RE: Longridge Subdivision
Subdivision Amendment Application

**Town of Richmond
Request Form for
Subdivision Approval Amendment**

Final Plat
Longridge
Subdivision

Date revised	Description	Checked	Date
Design	SDG		
Drawn	SDG		
Checked	SWH		
Scale	1" = 20'		
Date	Feb. 11, 2021		
Project	20303 Yantz Hill Road		Richmond, Vermont
Wastewater Disposal Plan - LOT #4			
LONGRIDGE SUBDIVISION			
KREBS & LANSING Consulting Engineers, Inc. 164 Main Street, Colchester, Vermont 05446			
			WW-1

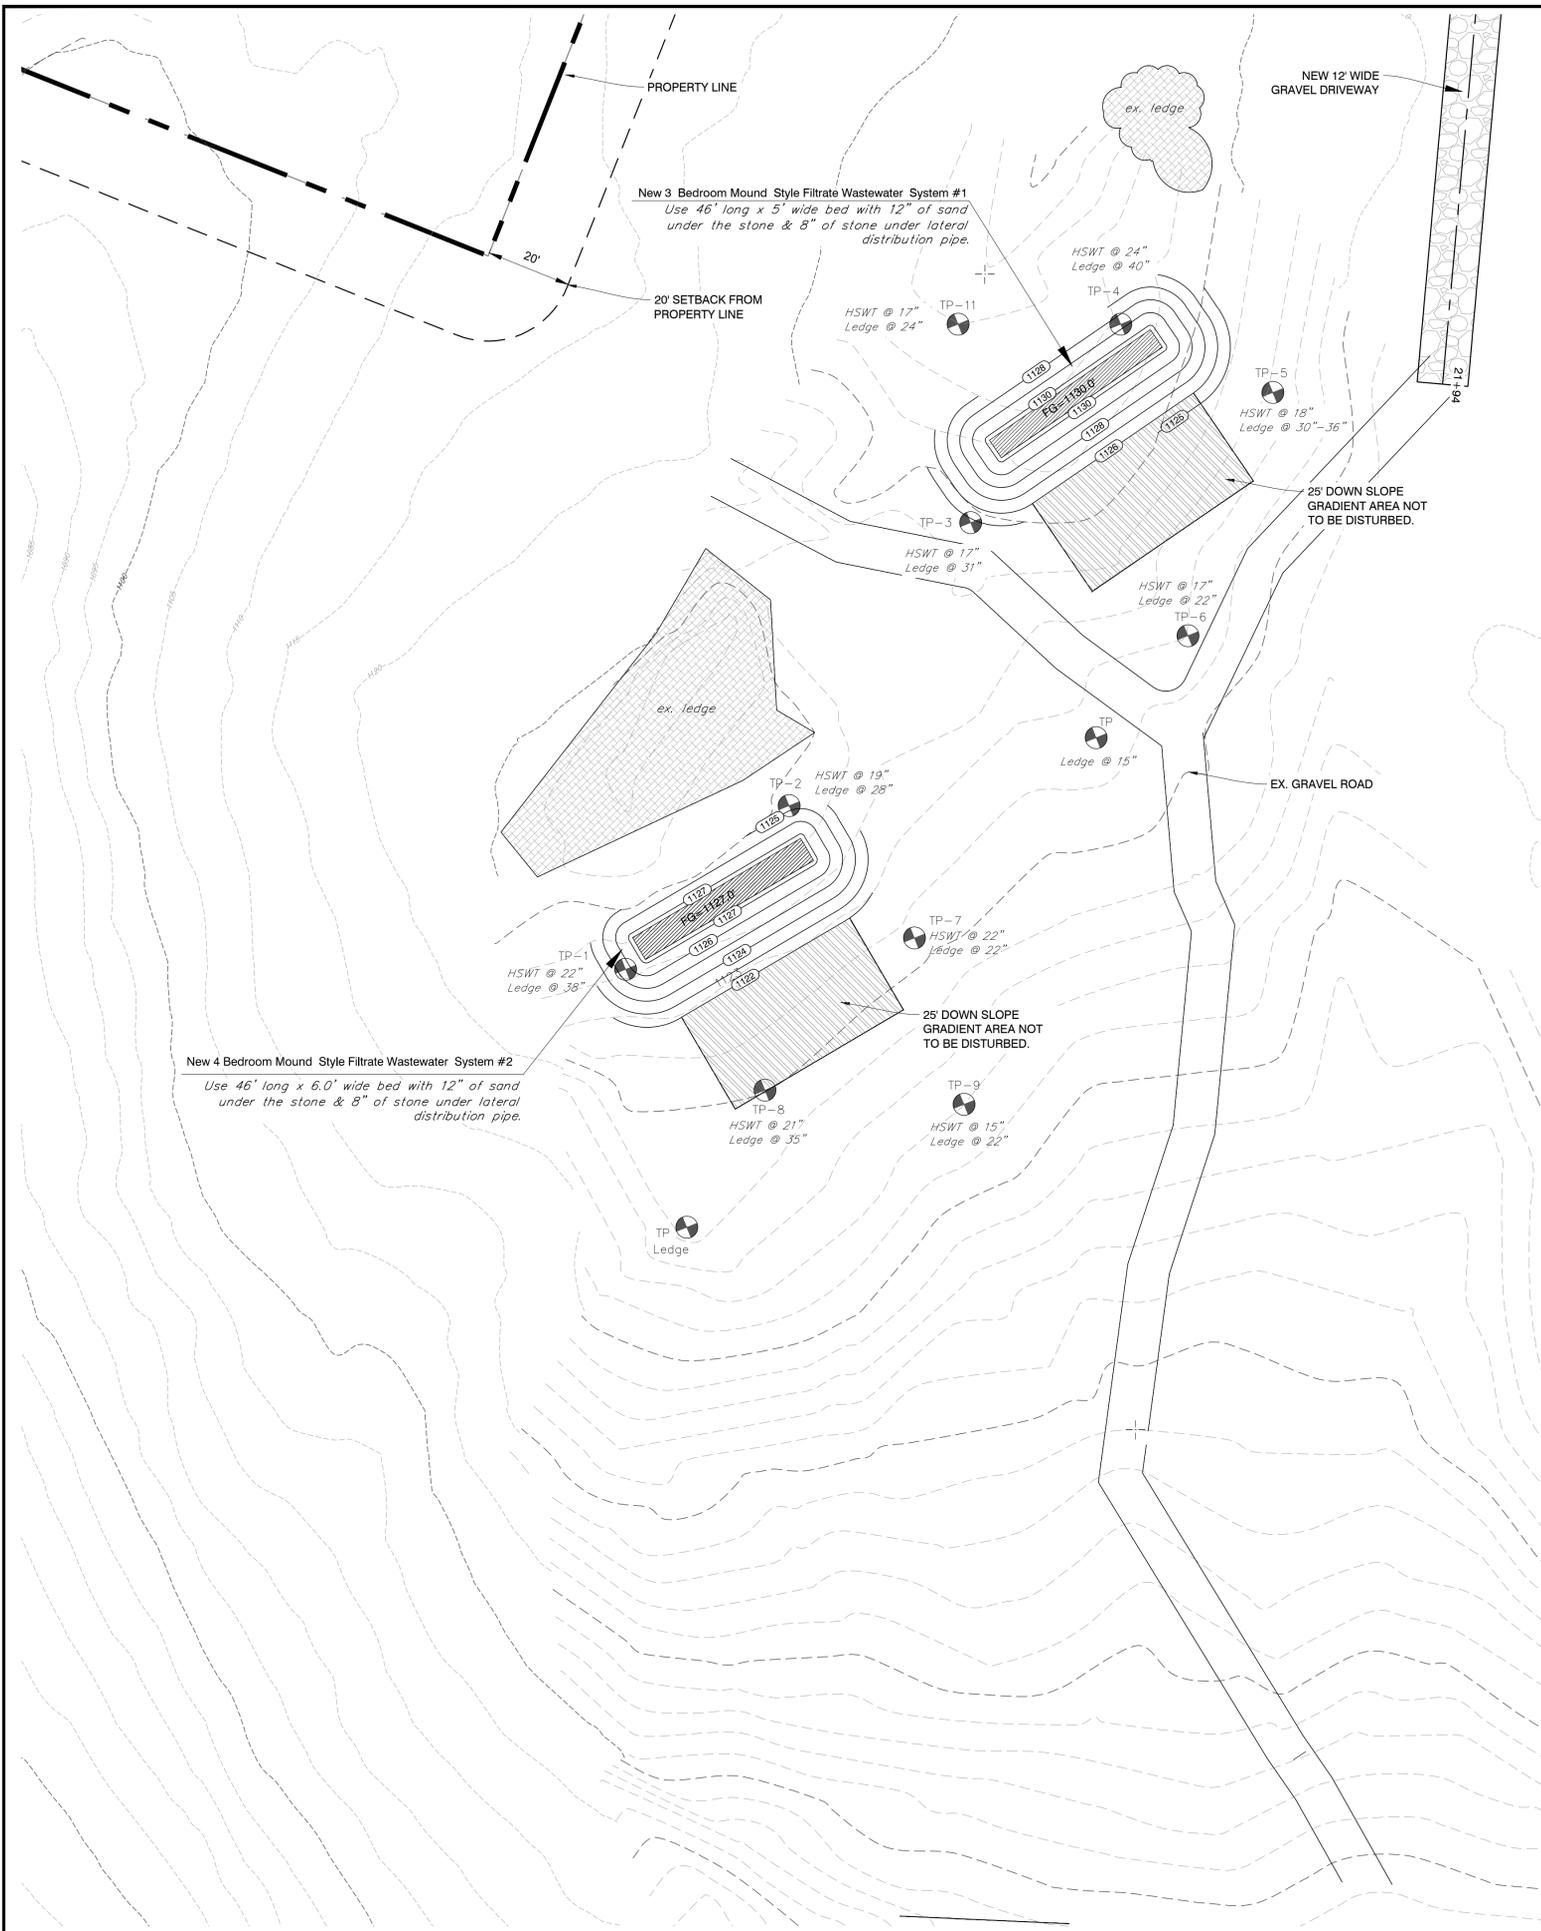
On behalf of the Owner of Lot #4 at the Longridge Subdivision located off Fiddlehead Lane in Richmond, we have prepared a subdivision amendment application. The Owner of the undeveloped lot #4 would like to remove language from the final plat that prevents development of the lot. The existing language reads *"No building construction requiring sewage disposal may take place on Lot #4 until verification, as required by the Town of Richmond, of soil suitability for on-site wastewater disposal or confirmation of receipt of municipal sewer allocation to service this lot has been submitted to the planning commission."*

Remove note on Lot 4 that states "No building construction requiring sewage disposal may take place on Lot #4 until verification, as required by the town of Richmond, of soil suitability for on-site wastewater disposal or confirmation of receipt of municipal sewer allocation to serve this lot has been submitted to the Planning Commission." Suitable soils have been found for the proposed 4 bedroom and ADU. Soil test hole information and wastewater disposal system designs are attached.

Date revised	Description	Checked	Date
February 11, 2021	Remove Lot 4 note	sdg	02/11/21
October 21, 1996	Lot 4 note	iaj	10/21/96

No building construction requiring sewage disposal may take place on Lot #4 until verification, as required by the Town of Richmond, of soil suitability for on-site wastewater disposal or confirmation of receipt of municipal sewer allocation to serve this lot has been submitted to the Planning Commission.
